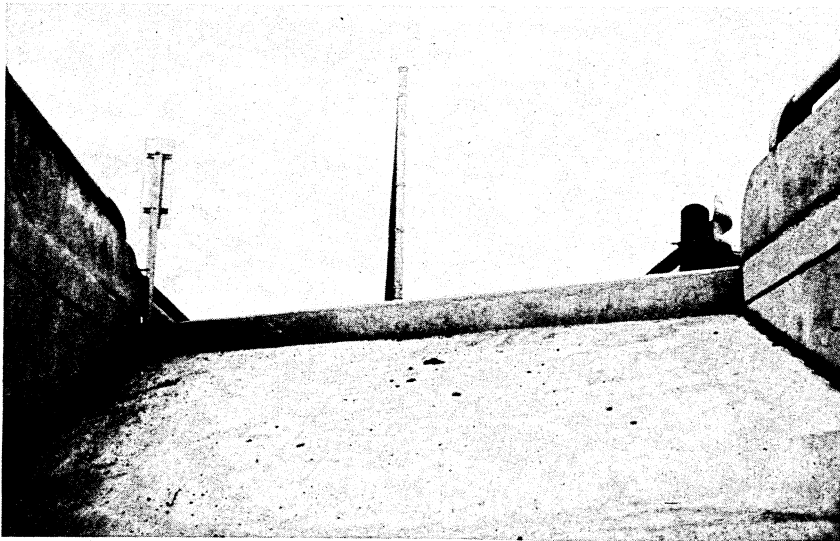
This again is a closeup view of twin bridges, rather close together. And again the lack of anchorage between the rail and the structure. This is repeated over and over.

This rail up on top of a curb, of course, would not function as well as one that was clear.
